UNITED STATES PATENT AND TRADEMARK OFFICE

APPLICATION NO.	FILING DATE	FIRST NAMED INVENTOR	ATTORNEY DOCKET NO.	CONFIRMATION NO.
10/738,364	12/17/2003	Theodore B. Mulle	2066/U	8555

Office Action Summary	Application No. 10/738,364	Applicant(s) MULLE ET AL.	
	Examiner Faye Francis	Art Unit 3725

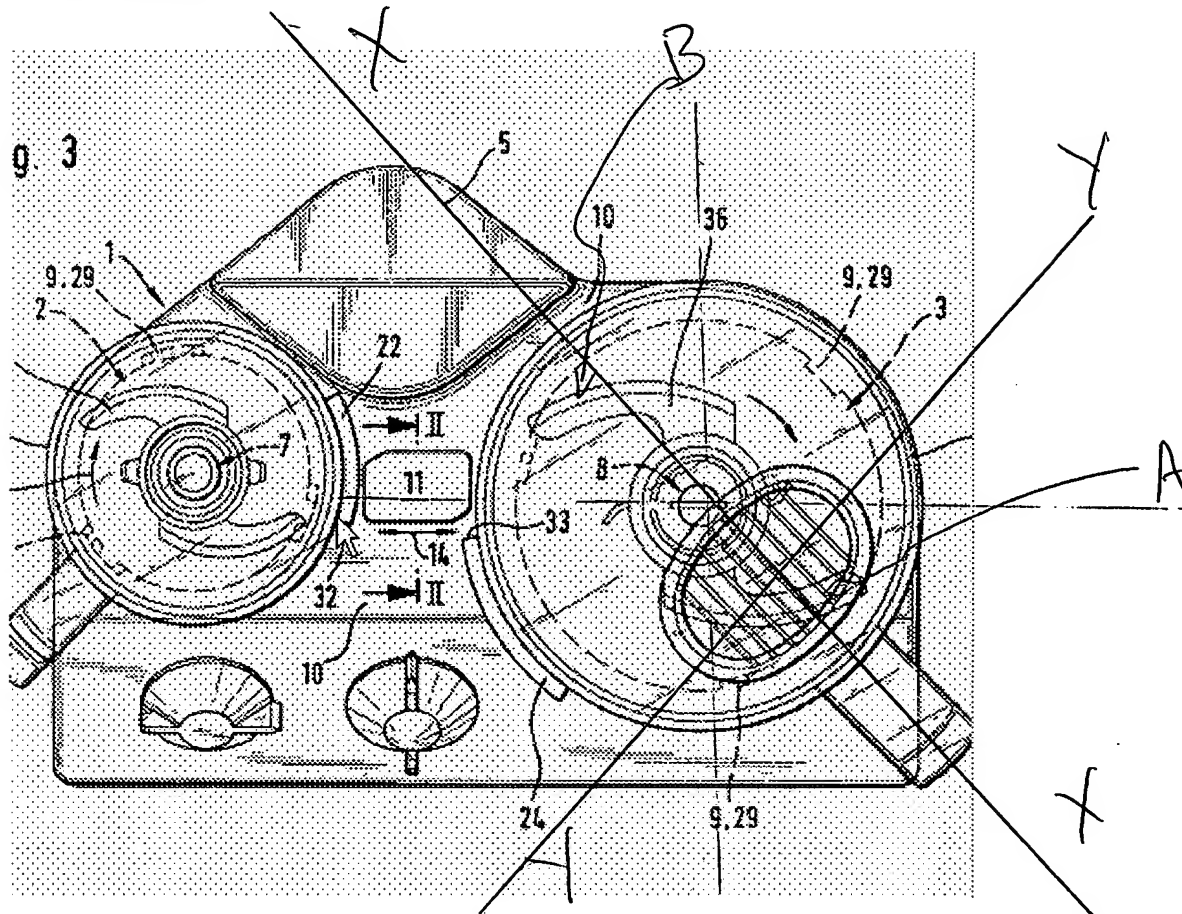
Borger discloses in Figs 1-5 (also see Figure below wherein the letters A-B have been added by the examiner), a cover assembly for food processing appliance comprising: a cover for cooperating with a container [housing 5, base 1 and bowl 6], the container cooperating with an operating base [base 1 and mount 3], the cover having an upper side with a predefined ingress area A, the operating base having a rotating tool

36 with a center of rotation [spindle 8] and a peripheral impact region B and the peripheral impact region being radially distanced from the center of rotation. Also, Brady discloses wherein the ingress area overlies at least a substantial portion of an outermost portion of the peripheral impact region relative to the center of rotation and wherein the ingress area does not overlap the center of rotation [see the Figure below] when the cover operatively connected to the container and the container is operatively connected the operating base. Additionally, Brady discloses the ingress area has a cross-sectional area **substantially equal** to half that of a lower side of the cover [see the Figure below, the cross section along the line X-X appears to be **substantially equal** to half that of a lower side of the cover and the cross section along the line Y-Y appears to be **equal** to half that of a lower side of the cover] and the ingress area is shaped so as to overlay at least a distal end of the impact region [see the Figure below].

Should Brady be later deemed not to meet claims 1-5, 7-11, 13-17 and 19-20 because Brady does not disclose the accessory for cooperating with the ingress area, it would have been obvious to provide the device of Brady with an accessory in order to push the material down the feed tube.
